ADDENDUM NO. 1

1 August 2019

To all Bidders on the Project titled: **Ayer DPW Recreation Department Garage**

Ayer Department of Public Works
25 Brooks St
Ayer, MA
Contact: dVanSchalkwyk@ayer.ma.us
Project #: 17DPW12

A-001

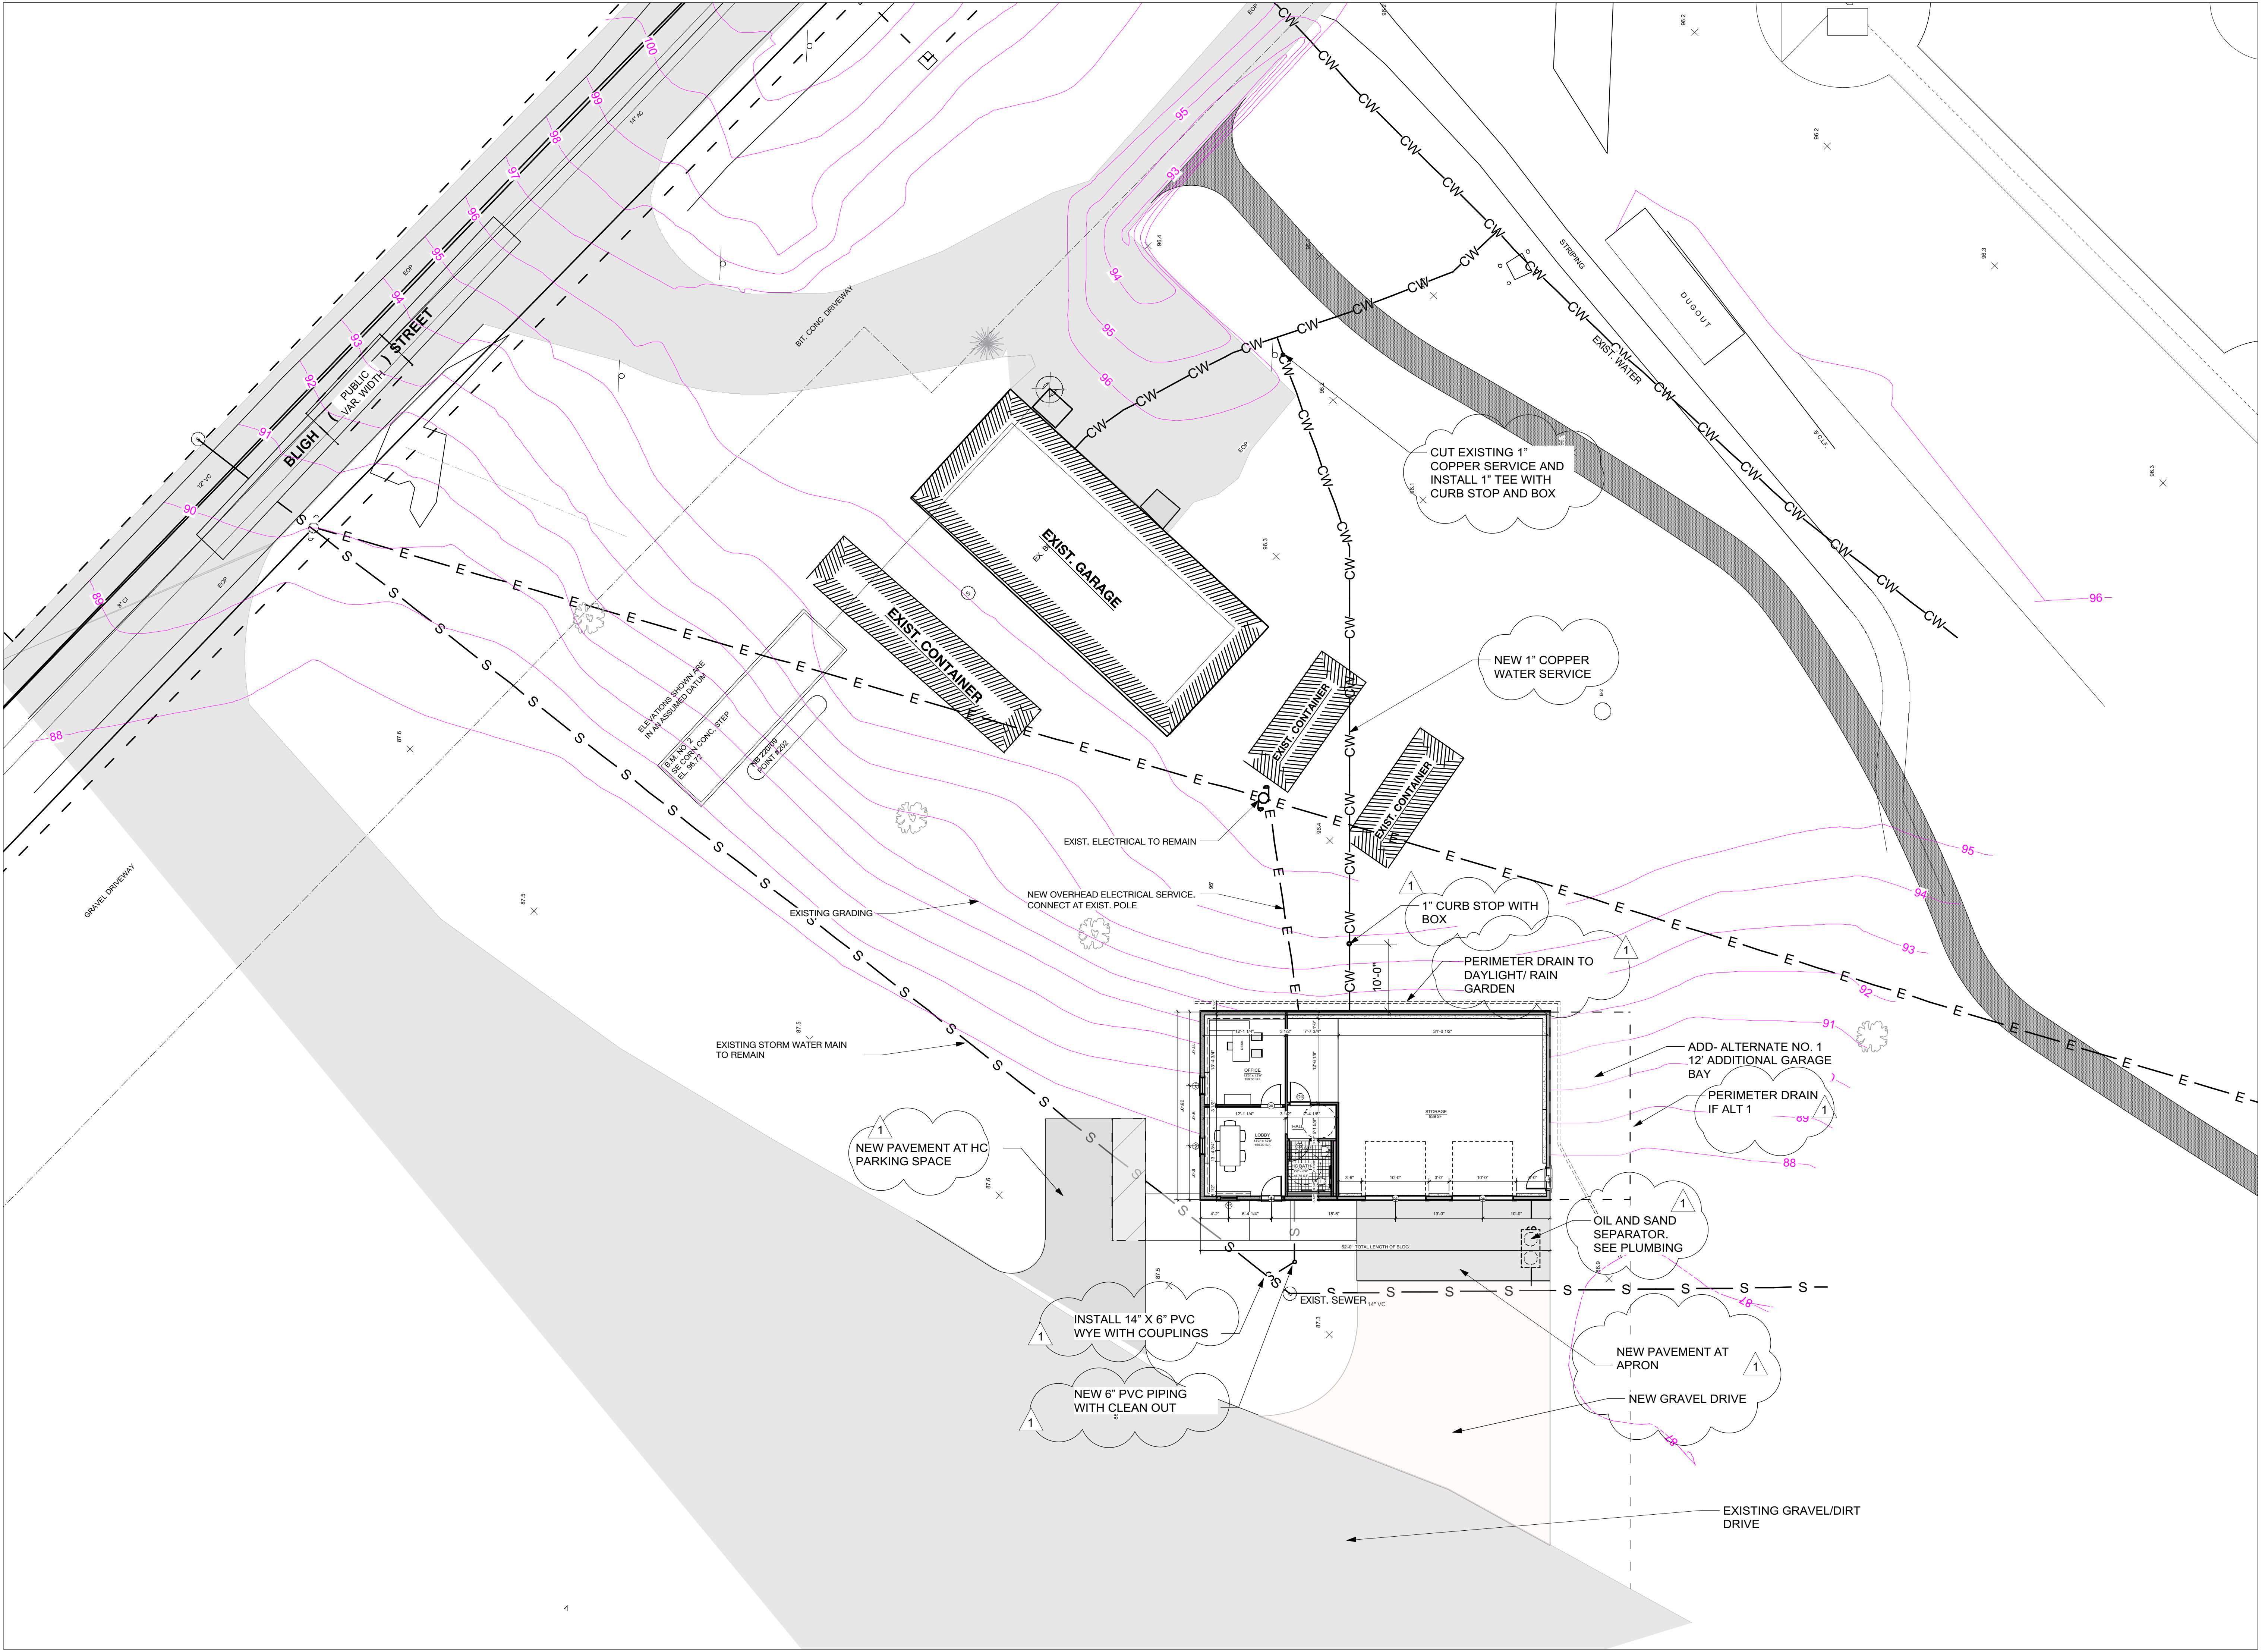
Item No. 2.: A-001 Site Plan

Issues / Revisions		
No.	Date	Notes
1	8/1/19	SITE UTILITIES/ PAVING
